Whitebox Student Campus,
Groody Road, Newcastle,
Castletroy, Co. Limerick

Stage 1 Road Safety Audit

| Document Ref: | P24170-PMCE-XX-XX-RP-SA-3_0001 |

3.1 Absence of Pedestrian Connectivity to Footpath on Groody Road

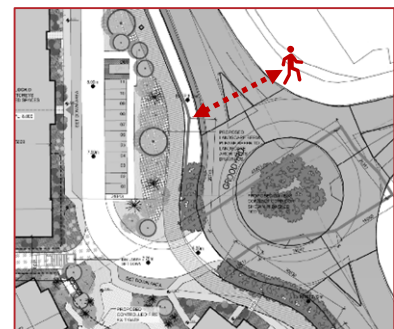
Summary: No pedestrian crossings have been indicated to/from the proposed development on Groody Road.

It is proposed to construct the student accommodation development on the western side of Groody Road with two pedestrian accesses indicated onto this side of the road, however, there is currently no footpath along the western side of Groody Road with an existing public footpath provided along the opposite side only. A pedestrian crossing has not been indicated on Groody Road with the nearest crossing being the Zebra crossing at the Groody Roundabout approximately 200m to the north.

There is likely to be a pedestrian desire line between the proposed development and the shops/residential developments on the eastern side of Groody Road, and it is unlikely that residents of the proposed development would travel north to this crossing. This may lead to pedestrians, who wish to travel between these developments, crossing Groody Road at locations where a driver may be less attentive to them, and insufficiently prepared to react, resulting in an increased risk of vehicle-pedestrian collisions.

There are also currently no pedestrian crossings at the roundabout at the proposed development access, which was noted as extremely busy at the time of the site visit, further exacerbating the problem.

In addition, the lack of a footpath on the western side of Groody Road will likely lead to pedestrians travelling in the verge or protected northbound cycle lane along the proposed development boundary, resulting in a risk of slips and falls, or pedestrian/cyclist collisions.

Measures should be provided to support the safe movement of pedestrians between the proposed development and developments on the eastern side of Groody Road.

| To be Completed by Designer | | | | To be Completed by Audit Team Leader |
|--------------------------------------|---------------------------|--|---|---|
| 3.1 | Yes | Yes | | |

3.2 Absence of Footpath at Parking Spaces

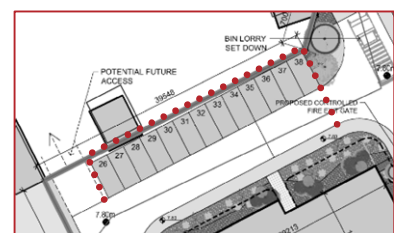
Summary: No footpath has been indicated around the parking spaces at the proposed development's northern boundary adjacent to Blocks A and B.

Parking spaces 26 – 38 have been indicated at the development's northern boundary adjacent to Blocks A and B. No footpath has been indicated adjacent to these parking spaces. The lack of a footpath at this location may lead to vehicle occupants travelling in the verge, which may rut over time, resulting in unstable ground and ponding, and an increased risk of slips, trips and falls.

Provide a paved footpath bounding these parking spaces and a pedestrian crossing to access the footpath on the opposite side of the road.

| To be Completed by Designer | | | | To be Completed by Audit Team Leader |
|--------------------------------------|---------------------------|--|---|---|
| 3.2 | Yes | Yes | | |

3.3 Provision of Crossings

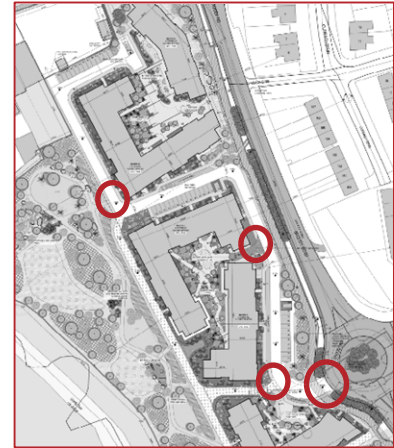
Summary: Details of pedestrian crossings within the development have not been indicated.

Pedestrian crossings have not been indicated within the development particularly at the development access and internal junctions where it is likely that these will be required to cater for pedestrians crossing the internal road network.

A failure to provide formal pedestrian crossings, with dropped kerbs and tactile paving, could lead to pedestrians crossing the carriageway at locations where drivers may be less attentive to them and insufficiently prepared to react safely resulting in an increased risk of vehicle-pedestrian collisions.

In addition, the lack of dropped kerbs and tactile paving at locations where pedestrians are likely to cross the carriageway would lead to pedestrians having to mount/dismount full height kerbs where there is a risk of trips and falls, and further accessibility issues for the visually and mobility impaired.

Pedestrian crossings, including dropped kerbs and tactile paving, should be provided at the development access and across side road junctions within the development.

| To be Completed by Designer | | | | To be Completed by Audit Team Leader |
|--------------------------------------|---------------------------|--|---|---|
| 3.3 | Yes | Yes | | |

3.4 Absence of Pedestrian Connectivity at Parking Spaces

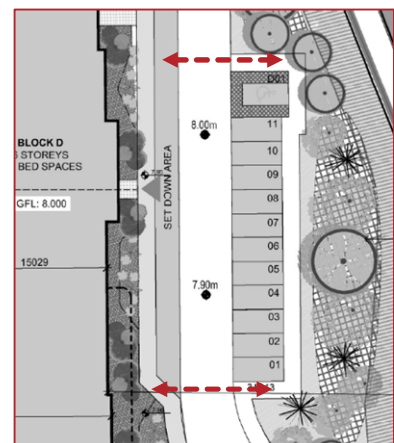
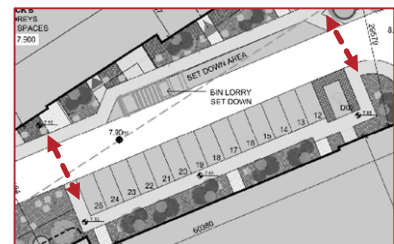
Summary: No pedestrian crossings have been indicated to cater for vehicle occupants travelling between their vehicle and the apartment blocks within the proposed development.

Parking spaces have been indicated within the proposed development on the opposite side of the development access road to the main entrance to Blocks B and D. Formal pedestrian crossings have not been indicated adjacent to these parking spaces to accommodate vehicle occupants crossing between their vehicle and the apartment blocks. A failure to provide a formal pedestrian crossing, with dropped kerbs and tactile paving, at these locations could lead to pedestrians, particularly mobility impaired pedestrians, being unable to safely and independently enter the carriageway to cross to the opposite footpath.

This could result in slips, trips and falls as these pedestrians attempt to descend the kerb, or an increased risk in visually impaired pedestrians unintentionally entering the carriageway where they could be struck by vehicles.

Formal pedestrian crossings, including dropped kerbs and tactile paving, should be provided at pedestrian desire lines between the proposed parking spaces and the opposite footpath adjacent the main apartment block entrances.

| To be Completed by Designer | | | | To be Completed by Audit Team Leader |
|--------------------------------------|---------------------------|--|---|---|
| 3.4 | Yes | Yes | | |

3.6 Restricted Forward Visibility at Bends

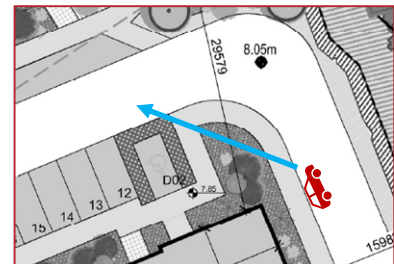
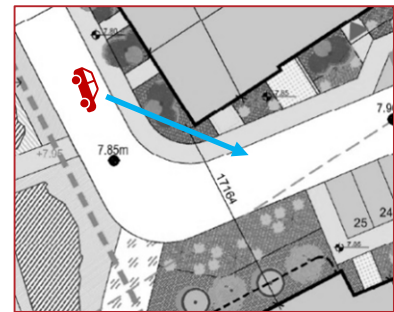
Summary: Forward visibility of drivers within the proposed development may be restricted by proposed planting and building boundaries on the inside of horizontal curves.

Horizontal curves have been indicated within the alignment of the development's internal access road between Blocks B and C. It is unclear if sufficient forward visibility will be available for drivers on the inside of these horizontal curves due to the trees and building boundaries located on the inside of the bend. This may lead to drivers being insufficiently aware of oncoming opposing traffic resulting in a risk of low-speed head on collisions.

Sufficient forward visibility should be provided for drivers on approach to, and throughout, the horizontal curves.

| To be Completed by Designer | | | | To be Completed by Audit Team Leader |
|--------------------------------------|---------------------------|--|---|---|
| 3.6 | Yes | Yes | | |

3.10 Level Difference

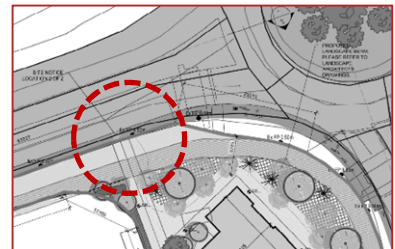
Summary: The existing level difference between the site and the adjacent public footpath on the southern side of the R445 may result in a steep gradient on the proposed pedestrian path between the R445 and the development.

A pedestrian route from the proposed development to the footpath on the southern side of the R445 has been indicated at the development's northern boundary. At the time of the site visit, the Audit Team noted a level difference between the development site and the footpath on the R445. It is, therefore, unclear if the gradient of this access path would be suitable for all pedestrians, particularly the mobility impaired. If not, this may increase the risk of slips, trips and falls and personal injuries.

The access path should have a smooth, non-slip surface and should provide a gentle gradient that can be safely traversed by all road users.

| To be Completed by Designer | | | | To be Completed by Audit Team Leader |
|--------------------------------------|---------------------------|--|---|---|
| 3.10 | Yes | Yes | | |

4 Observations

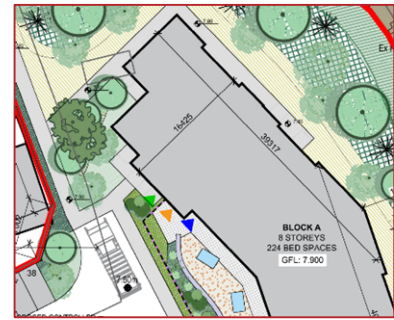
- 4.1 The Main Lobby Entrances have not been indicated at Blocks A and C. It is, therefore, unclear how pedestrians will access these blocks, i.e. from the development's internal footpath network or from routes between other apartment blocks. The Main Lobby Entrances should be clearly marked on the drawings and sufficient routes provided to these locations.
